20 Thurlow Road
REVISED DESIGN 2018/11/14
20 Thurlow Rd, London NW3 5PP

ROOF EXTENSION
AXONOMETRIC VIEW LOOKING NORTH-WEST

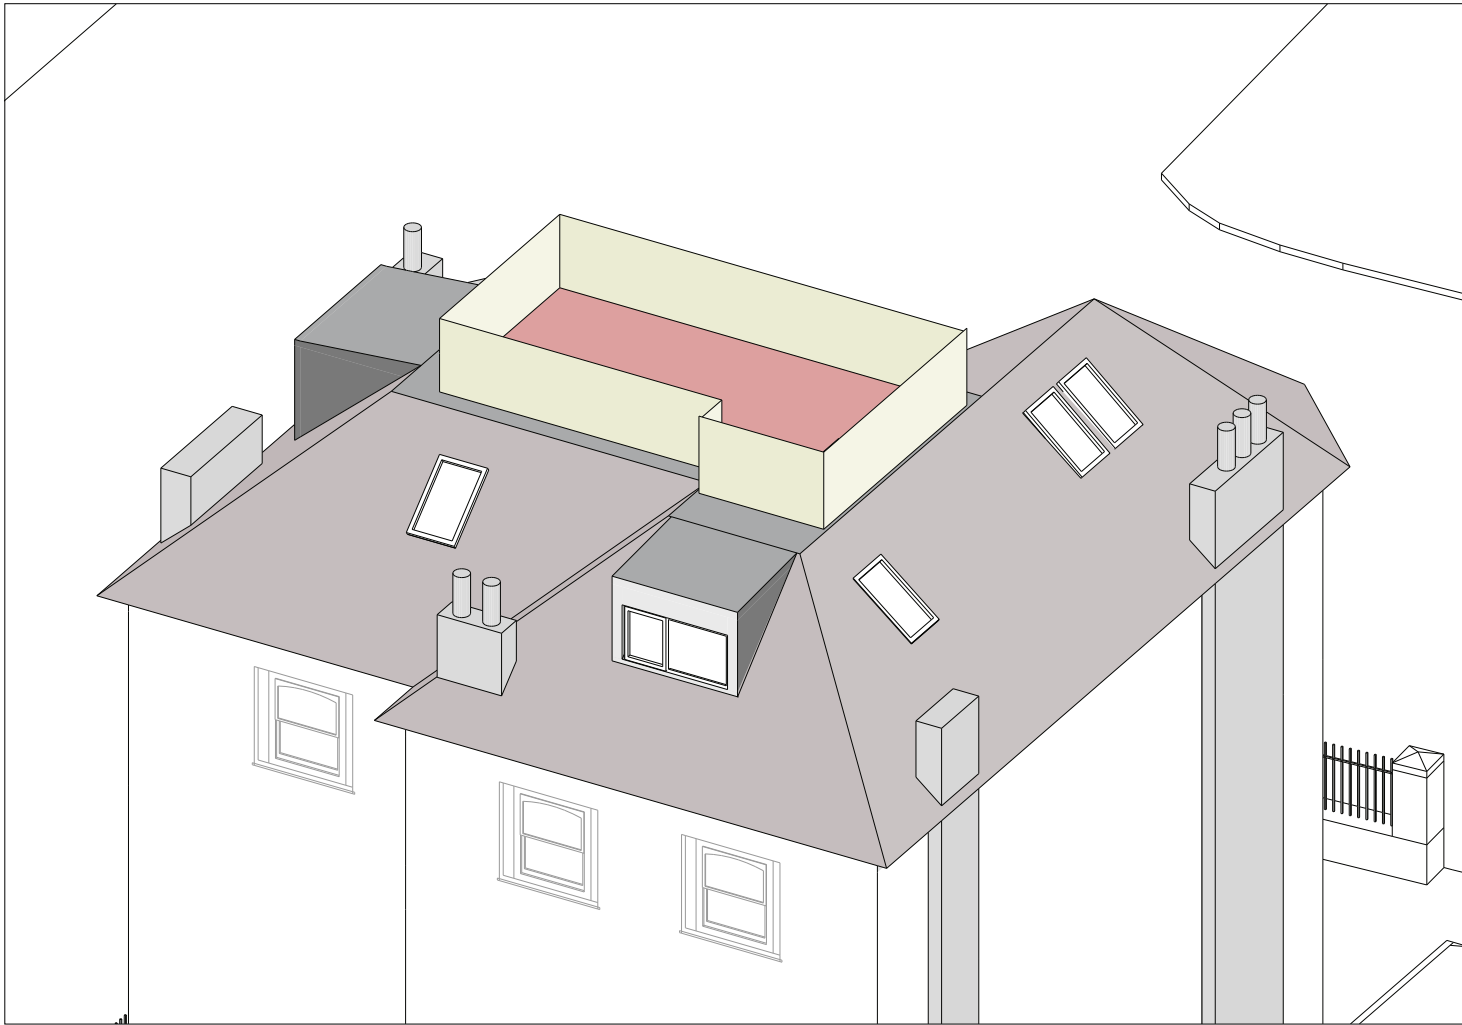
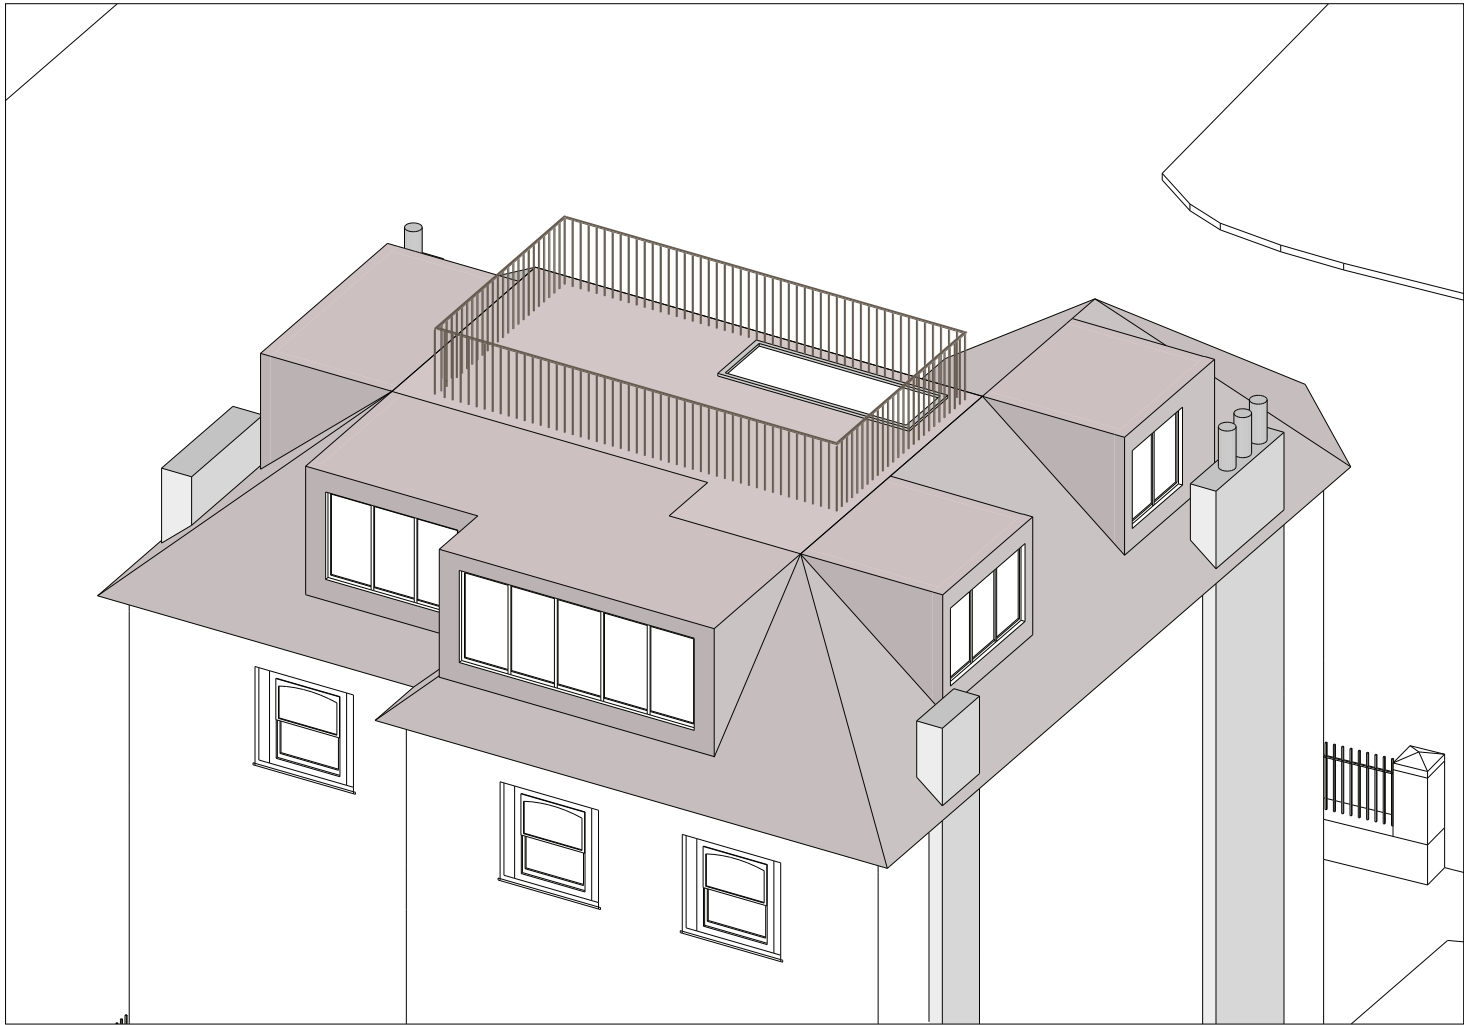
The proposed roof extension due to its bulk, scale, detailed design and projection appears dominant and top heavy, detracting from the character of the host property and streetscene. The scale of the proposed roof extension should be significantly reduced in size and be more sympathetic to the scale of the existing dormers which are more in keeping with the character of the property/surrounding area. The loss of the ridges is unacceptable, however another small dormer on side elevation facing adjoining property on Thurlow Road and a further small dormer to the rear may be acceptable.

The revised proposal for the roof extension is significantly reduced in size and respects the scale and character of the surrounding area. The ridgelines remain untouched where visible, especially to the front. Our decision to retain the existing side chimney breasts further disguises any rear alterations from a street perspective.

ROOF PLAN

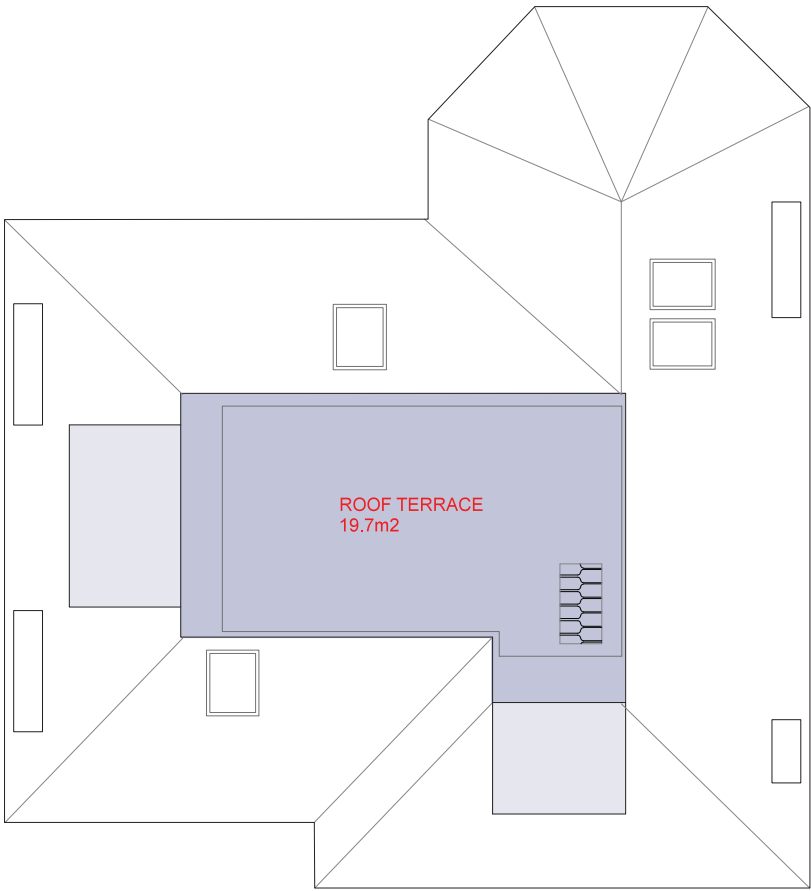
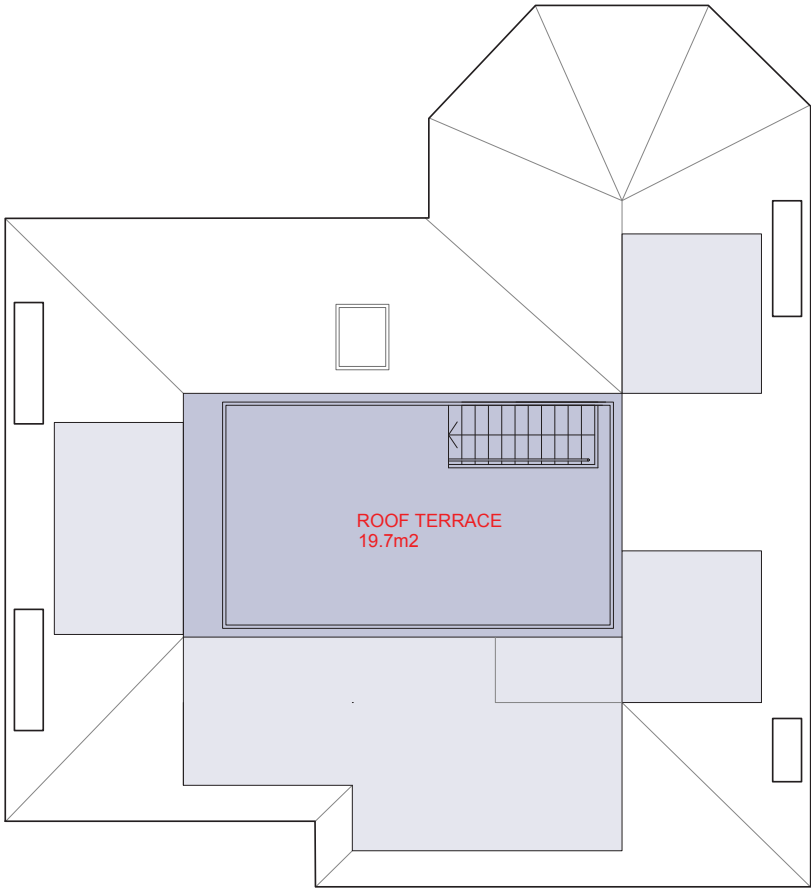
- The extension of the existing terrace would add additional clutter to the existing roof and host building overall, by adding a significant amount of glass balustrade. You are therefore advised that an increase in size of the terrace would not be supported by officers. The screening of the existing terrace should be replaced with fine railings.

- The proposed increase in terrace size, would intensify the use of the roof area, which raises concerns in relation to the impact on the amenity of the neighbouring occupiers in terms of overlooking and noise disturbance.

The size of the roof terrace will remain as it is. The screening will be replaced by a fine steel railing.
